**Part Change Notification:**

**Change to MLS Flatpack series electrolyte system**

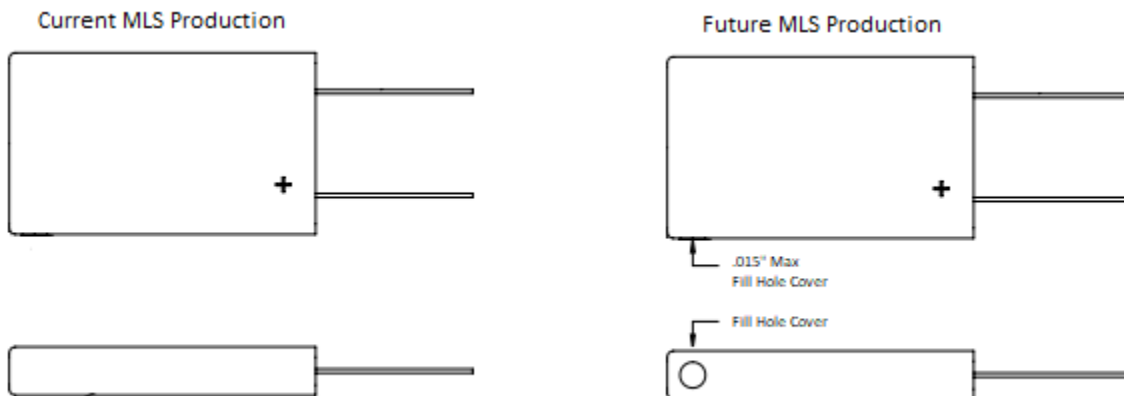
We have conducted exhaustive tests with the new electrolyte system and we can assure our customers that there will be no change to the form, fit, or function of the capacitors. The only discernable change will be to the fill-hole location. As an example, the following drawing shows the laser welded fill-hole repositioned to the narrow side and toward the bottom of the capacitor.

Starting July 7, 2018, we will begin manufacturing MLS part numbers with the new electrolyte and change to fill-hole location. There will be no change to the part number. The conversion of the entire series to the new electrolyte is expected to take 6 months.
